2024 Final: independently checked solutions

EE3032 Introduction to VLSI Design, NCU

The two original photographed exam pages and both supplied student answer sets were read. The original text, complement bars, circuit contacts and capacitance definitions govern this report; marks of 89 or 92 are only source provenance. Correct portions are retained after independent derivation. Incorrect charge-sharing cases, incomplete physical layout extraction and misread XOR equations are repaired. At the user's explicit choice, Q4 and Q6 present both the literal model and the classroom convention, with their incompatibilities visible. No process measurement is invented.

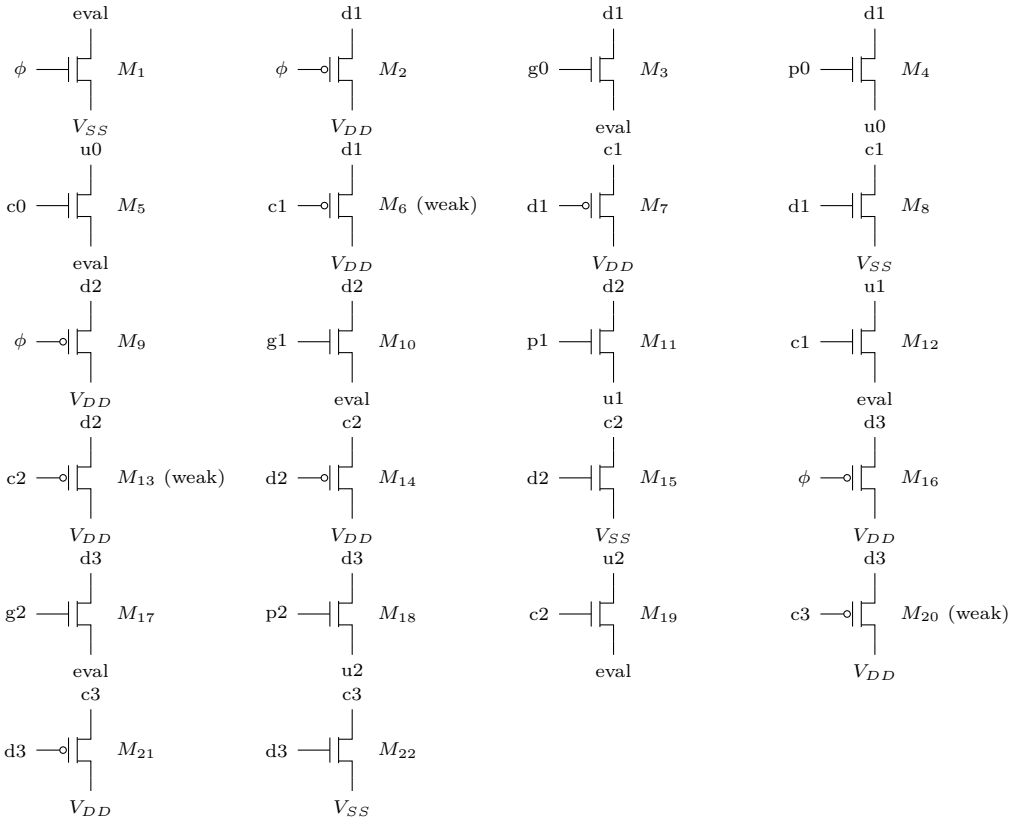
The student's three separately footed domino stages implement the recurrence, but a shared footer makes the requested multioutput structure explicit. Do not connect raw dynamic drain nodes by bidirectional propagate pass devices without additional constraints: independent p/g words can back-discharge a previously false carry. All 128 independent p/g/c0 combinations are checked; no unprinted p/g exclusivity constraint is used.

Each dynamic node d_i is precharged high and drives an output inverter $c_i = \bar{d}_i$. Its evaluation network has a generate branch g_{i-1} in parallel with the series propagate/carry branch p_{i-1}, c_{i-1}. The three branches share one clocked evaluation footer; each dynamic node has its own precharge device and weak keeper. This is an explicit shared multioutput cell, with 22 core MOSFETs including output inverters/keepers. Stable input p/g/c0 values are established before evaluation; c1/c2 start at zero and can only rise, making same-clock cascading monotonic.

(a) Read the middle clock and output bar

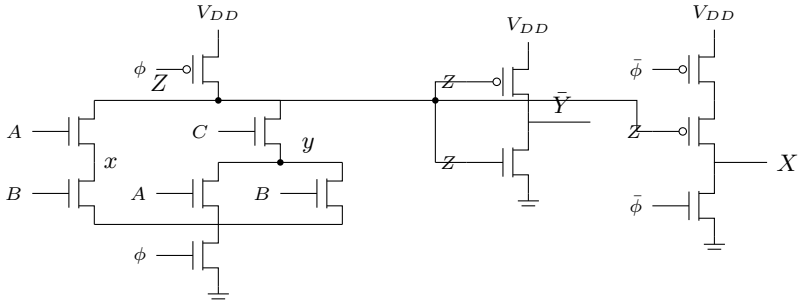
The middle output is printed $\bar{Y}$; call that physical node Y_b to distinguish the label from its Boolean value. Its upper pMOS and lower footer use $\bar{\phi}$, not Z. For $\phi = 0$, the left gate precharges Z high while the middle stage evaluates low. For $\phi = 1$, the middle pMOS precharges Y_b high and its footer is off, independent of F. Thus it does not evaluate the first gate's data in the intended evaluation phase. The right p-type branch correctly accepts falling Z and gives X=F. The middle clock overbar touches its gate wire in this photograph; a barred clock is the selected transcription, but the touching stroke cannot establish that glyph definitively. If that touching stroke instead denotes only the wire and the label is unbarred, the middle becomes a same-phase n-dynamic cascade: an initially high Z can discharge it before Z falls, and it cannot recharge during evaluation. It is still invalid, and the static repair below works for either clock reading.

One valid repair makes the middle stage a static inverter: **rewire the upper pMOS gate from the clock to Z, and remove the footer** (or tie it permanently on). Both inverter gates then use Z. It resets $Y_b = 0$ while Z is precharged high and gives $Y_b = F$ in evaluation. Keep the right p-type branch on raw Z. The prompt does not impose another Boolean output specification; this repair chooses $Y_b = X = F$.

The student's alternate inserts an inverter between Z and the middle nMOS and changes the middle clock to ϕ. That is also valid n-type domino: its rising F input discharges Y_b, giving $Y_b = \bar{F}$ after evaluation. Retain it as a valid alternate with this explicit polarity; add an output inverter only if the selected specification requires F. "Dynamic gates cannot cascade" is too broad: phase and input monotonicity determine validity.

(c) Longer clock intervals require retention

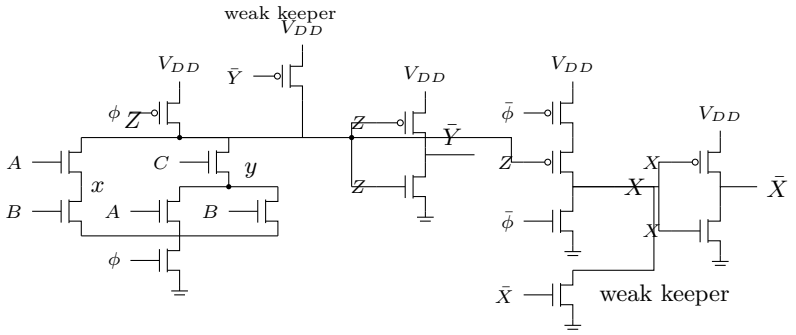
With precharge/evaluation clock held for a long time, a floating dynamic rail can leak across a logic threshold; purely capacitive storage does not provide indefinite retention. Add a weak pMOS feedback keeper from VDD to

Z, controlled by static $Y_b = \bar{Z}$. Add a weak nMOS keeper from X to VSS, controlled by a static inverter's $\bar{X}$. These hold the otherwise floating high Z and low X states respectively. The evaluating network must overcome its weak keeper until the feedback disables it; arbitrary device strengths cannot be inferred from the prompt.

This addresses ideal retention and practical leakage over a designed interval. Actual unlimited stopping time and noise margins require device/leakage/keeper sizing not supplied by the exam. The complementary X-control inverter is shown explicitly; adding only a left-rail keeper would omit the right p-type storage rail.

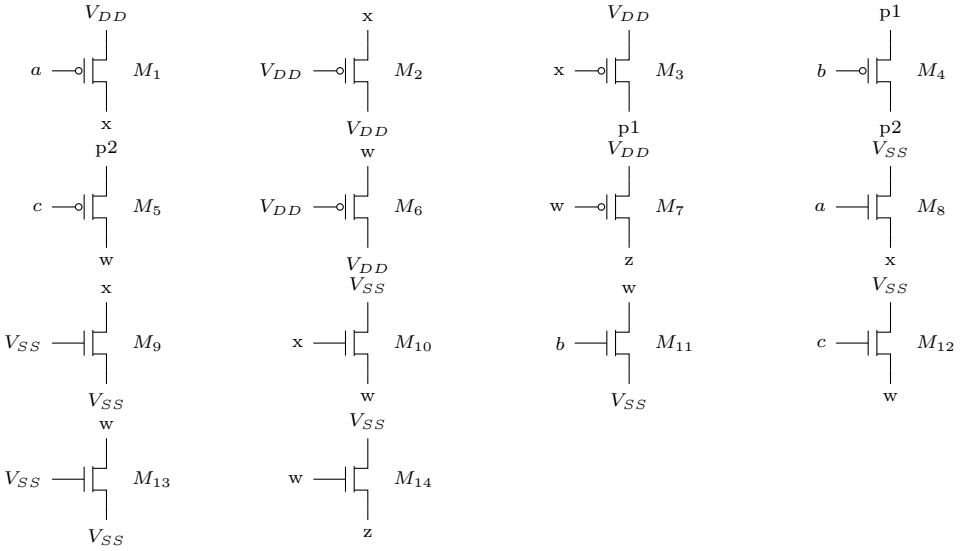
Only black contact markers join metal to poly/diffusion. Uncontacted layer crossings stay insulated. The internal p1/p2 source/drain contacts do not connect to the VDD rail; treating those as power contacts would destroy the series pull-up.

The ten functional devices reduce to INV(a), NOR(x,b,c), and INV(w), with $x = \bar{a}$, $w = \overline{x + b + c}$ and $z = x + b + c = \bar{a} + b + c$. The student's functional NOR sketch is valid after excluding the off isolation devices, but its 10-device picture is not the full 14-crossing extraction requested. All eight a/b/c words and rail-exclusivity states are checked against the full physical graph.

The seven poly crossings of each active strip create **14 physical MOSFETs**. Four are intentionally off isolation devices: two pMOS gates tied VDD and two nMOS gates tied VSS. They cannot be omitted when drawing the literal layout's complete transistor schematic.

(b) Clock buffering at the 400MHz target

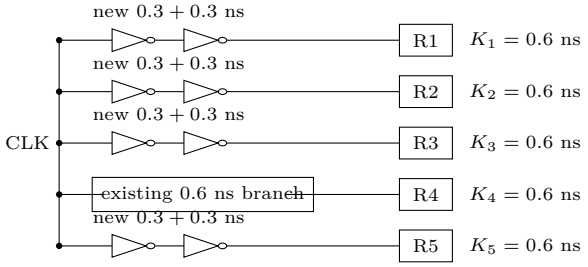
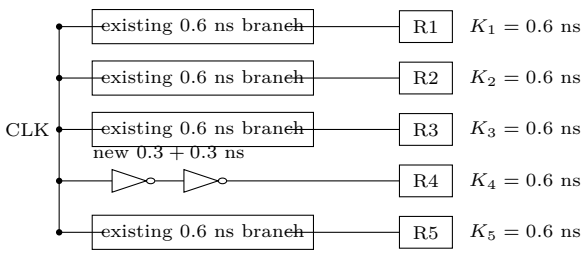
The student's launch-only buffering is not a valid repair of the literal original: it makes the unbuffered R5 capture early by0.6ns and increases its setup bound to3ns. Buffer placement follows clock arrival differences, not the grade.

Two 0.3ns inverters form a 0.6ns noninverting buffer. **Literal figure:** leave R4's existing 0.6ns branch and add a two-inverter pair to every R1/R2/R3 and R5 branch, making all arrivals0.6ns. **Adverse interpretation:** choose physical arrivals $(R1, R2, R3, R4, R5) = (0.6, 0.6, 0.6, 0, 0.6)$ns, then add the pair only on R4's shorter branch. Both balanced trees have setup bound2.4ns, safely within the requested2.5ns period. They permit416.667MHz under the same ideal setup model;400MHz is an achieved target, not the new exact maximum.

Literal source: buffer R1, R2, R3 and R5.

Adverse-skew interpretation: buffer R4 only.

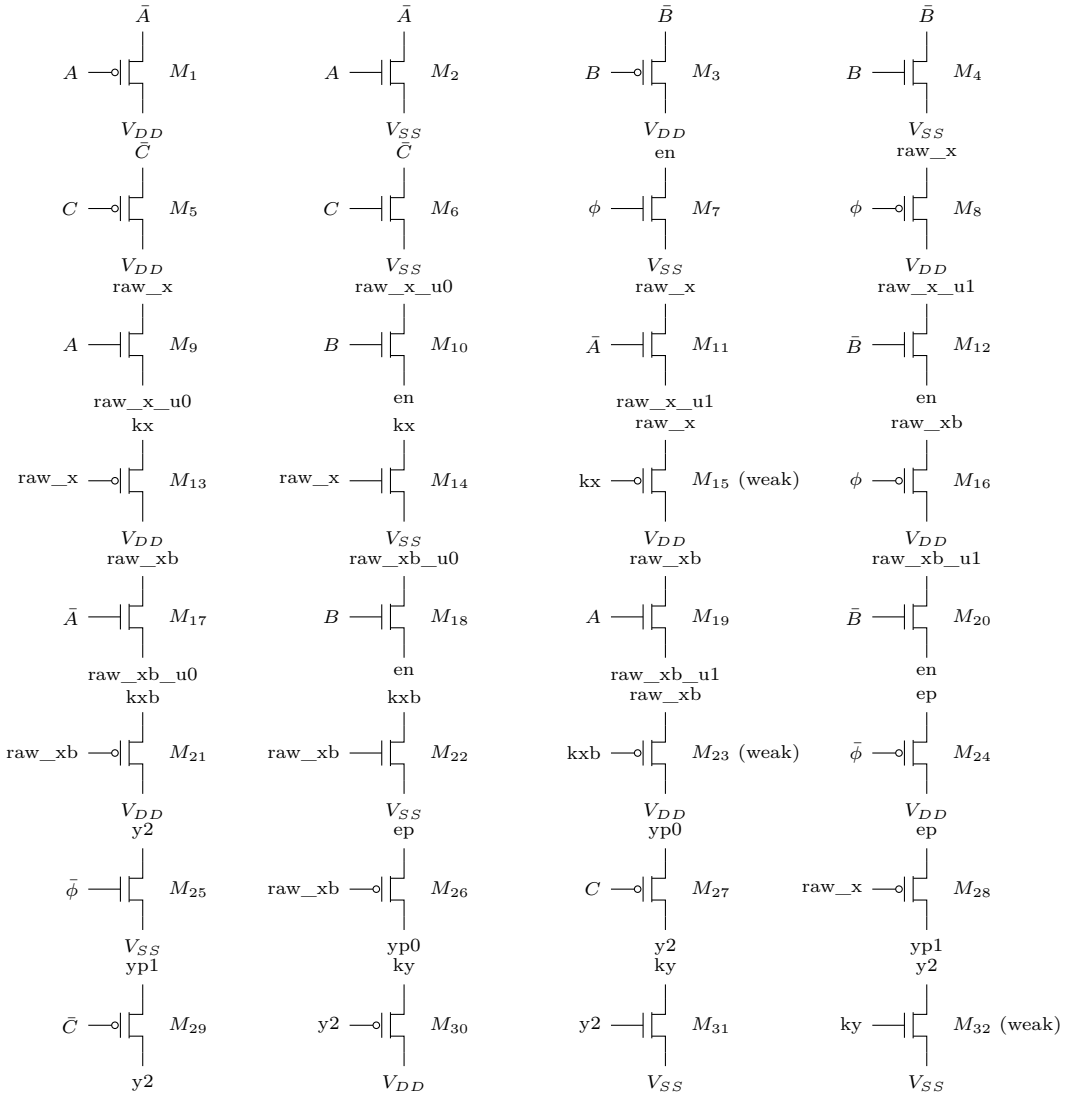
Hold requires $L + t_{ccq} + t_{cd} \geq K + t_{hold}$. In the balanced trees this is $t_{cd} \geq 0.1$ns. The prompt gives gate propagation delays, not their contamination delays, so a physical hold guarantee cannot be deduced. Under an explicitly ideal fixed gate-delay assumption, the shortest combinational path is1ns, giving hold slack0.9ns; these conditional checks are saved separately.

Use Y1=VSS for its exact steady-state constant function. Generate raw dual-rail n-type dynamic nodes $d_u = \bar{u}$ and $d_{\bar{u}} = u$ with complementary XOR/XNOR pull-down minterms. Both precharge high and can only fall during evaluation. A following p-type dynamic parity stage precharges Y2 low and evaluates through either series pMOS pair (d_u, C) or $(d_{\bar{u}}, \bar{C})$:

In the schematic, d_u = raw_xb and $d_{\bar{u}}$ = raw_x. The falling raw n-type rails monotonically enable the p-type network. True/complement A/B/C inputs must settle before evaluation; three input-complement inverters are included. Complementary clocks $\phi, \bar{\phi}$ are supplied externally. Weak complementary keepers retain floating states. This changes the original physical structure while preserving its Boolean outputs; the earlier timing numbers describe the original schematic, not this unsized replacement.
